NFPA 805 OBSERVATION VISIT TRIP REPORT

Location: Shearon Harris Nuclear Power Plant, near New Hill, North Carolina

Subject: Risk-Informed, Performance-Based Fire Protection Transition Pilot-Plant Observation Visit – Shearon Harris Nuclear Power Plant, North Carolina

Figure 1. Multiple Spurious Post-Transition Inspections

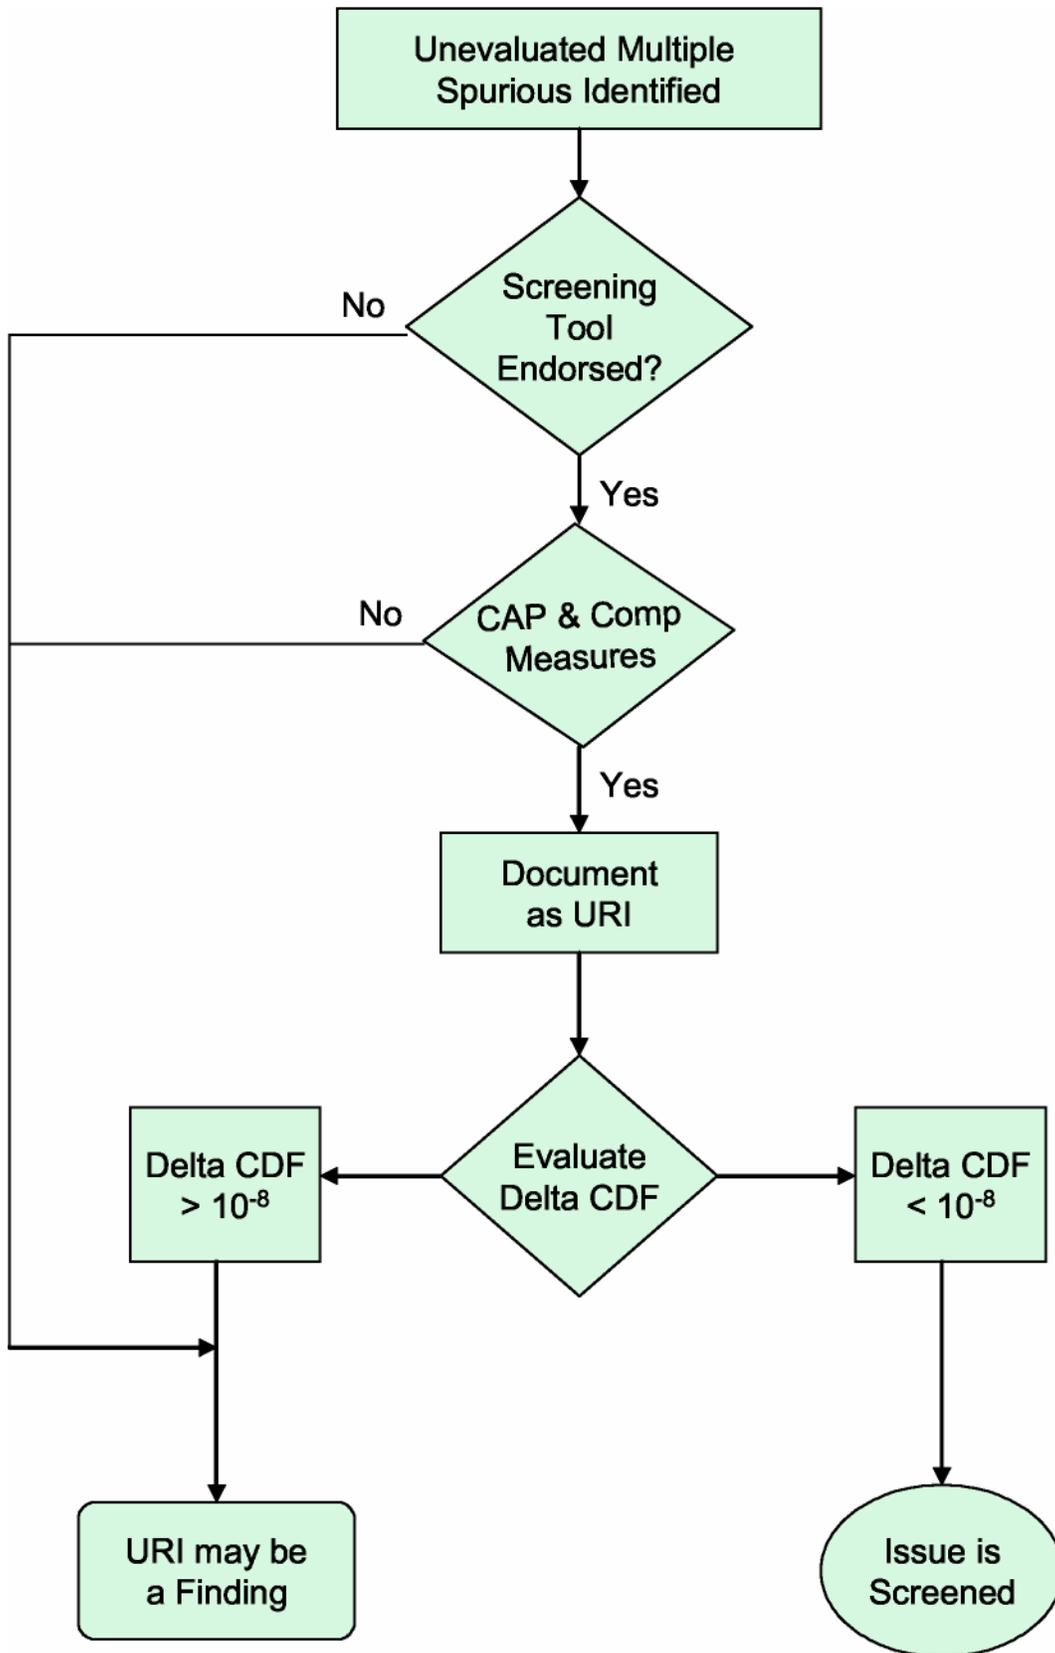
Status: OPEN. The November 2005 pilot-plant observation visit initially identified this issue. The NRC Staff reviewed the ROP relative to the treatment of newly identified multiple spurious operations that have unknown risk significance.

At the March 2006 pilot plant observation visit, the Staff presented a flow chart, illustrating how newly found multiple spurious circuits identified during an inspections, could be treated (See flow chart below). In addition to the flowchart, the following information was discussed:

Resolution Action(s)/Action Party: OPEN. Industry and pilot-plant participants agreed to review the flowchart, IMC 0612 questions, screening thresholds and provide feedback to the NRC at the next observation meeting. The industry may also submit an FAQ on the issue.
